Rezoning Transportation Analysis

Petition Number: 2021-118

General Review Information

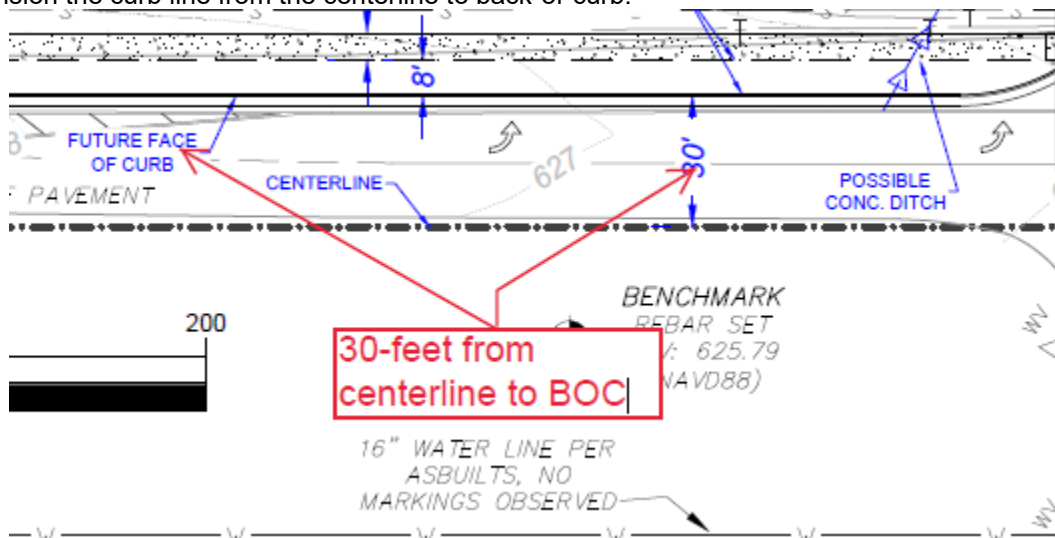
1. ~~Curb line:~~

- a. ~~Westinghouse Boulevard:~~ Curb and gutter is not required with this petition; however, the future location of curb and gutter will be 30 feet from the existing centerline measured to the back-of-curb.

~~Label and dimension the future back-of-curb from the existing centerline.~~

Update to Comment as a Result of the 11-15-2021 Site Plan: Revise the site plan by labeling and dimension the curb line from the centerline to back-of-curb.

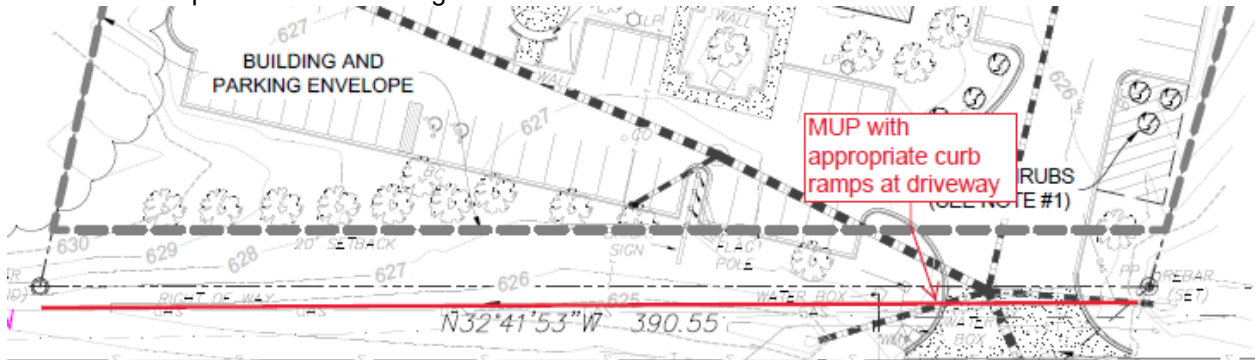
3. ~~Revise site plan and conditional note(s) to commit to dedicate 52 feet of right-of-way from the existing centerline of Westinghouse Boulevard. The site plan shall label and dimension the right-of-way from the road centerline.~~

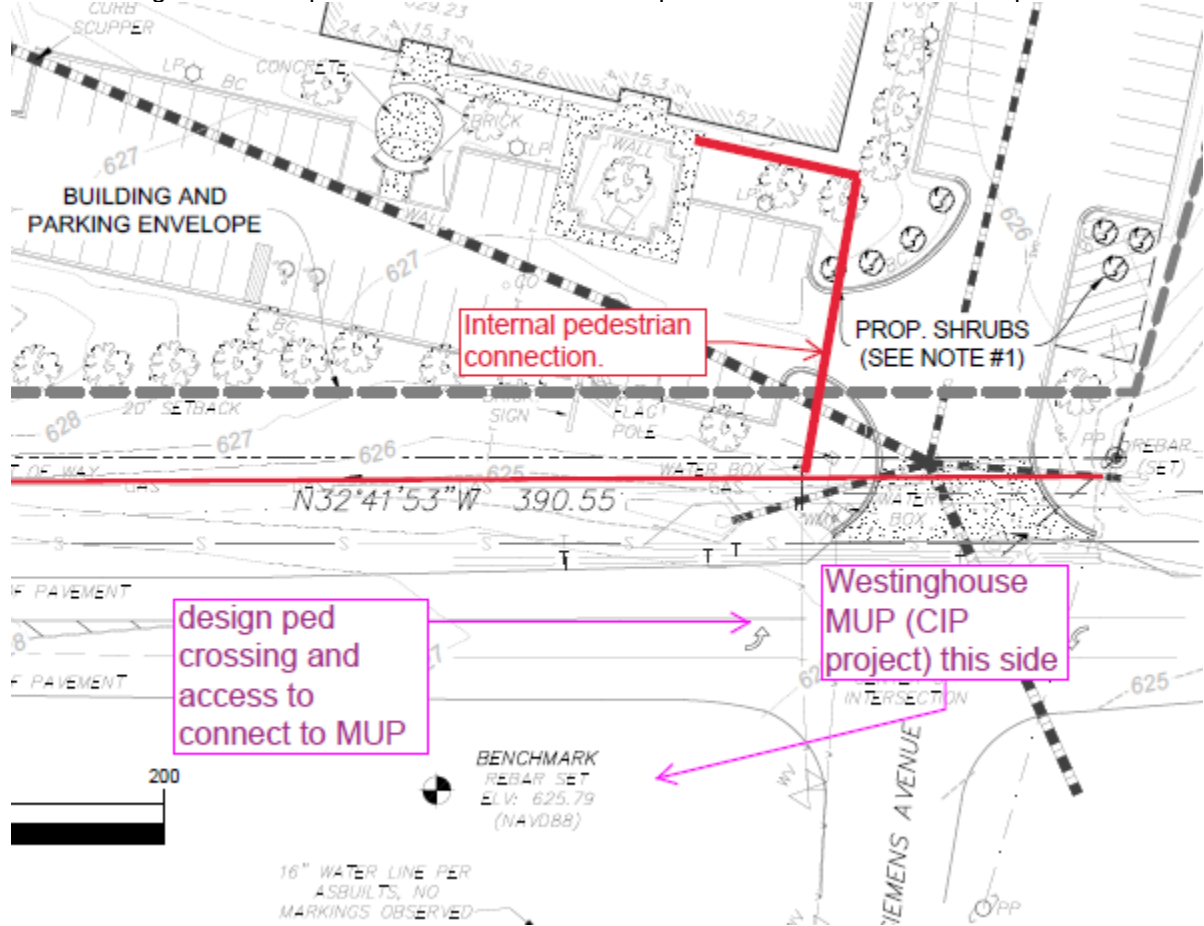
4. ~~Update to Comment after meeting with petitioner:~~ An 8-foot planting strip and 6-foot sidewalk will be provided. Revise site plan and conditional note(s) to commit to construct an 8-foot planting strip, and 12-foot shared-use path along the site's frontage of Westinghouse Boulevard. This shared-use path shall be placed relative to the future curb line location, noted in outstanding issue 1.a, and appropriate

ADA curb ramps will be provided across the existing driveway. The site plan shall label and dimension the shared-use path from the existing road centerline.

Comment resolved after coordination with petitioner: Update to Comment as a Result of the 11-15-2021 Site Plan: Revise the site plan by labeling the sidewalk and planting strip as "proposed".

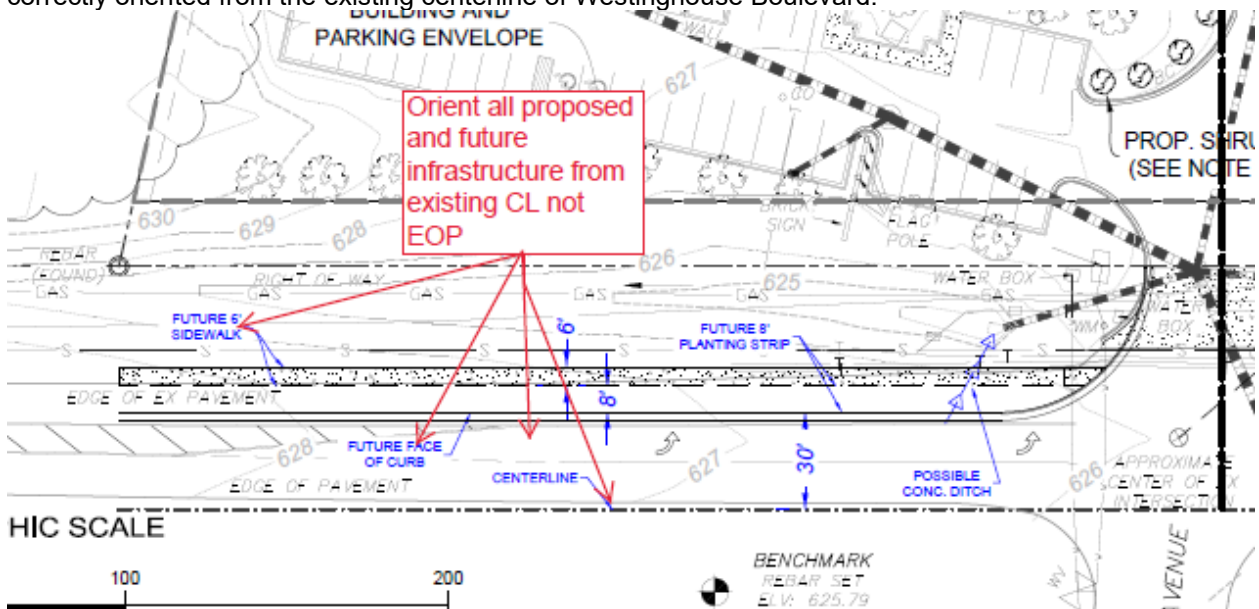
6. ~~A site plan note(s) specifying dedication and fee simple conveyance of all rights-of-way to the NCDOT before the completion of the City of Charlotte's Westinghouse Boulevard Multi-use Path Capital Improvement Project. CDOT requests rights-of-way set at 2' behind back of sidewalk where feasible. Update to Comment as a Result of the 11-15-2021 Site Plan: Revise the site plan and conditional note 4.c to by including a sidewalk utility easement placed 2-feet behind the proposed sidewalk.~~
depicted on the concept plan for the site.

- c. . The Petitioner will commit to commit to dedicate 50-feet of right-of-way from the existing centerline of Westinghouse Boulevard if the existing right of way is not adequate to meet this request.

- d. The Petitioner will commit to construct an 8-foot planting strip and a 6foot sidewalk along the site's frontage of Westinghouse Boulevard. The location of these elements will be measured as 30' from the existing curb with the 8' planting strip and 2-foot SUE placed behind sidewalk. behind and immediately adjacent to
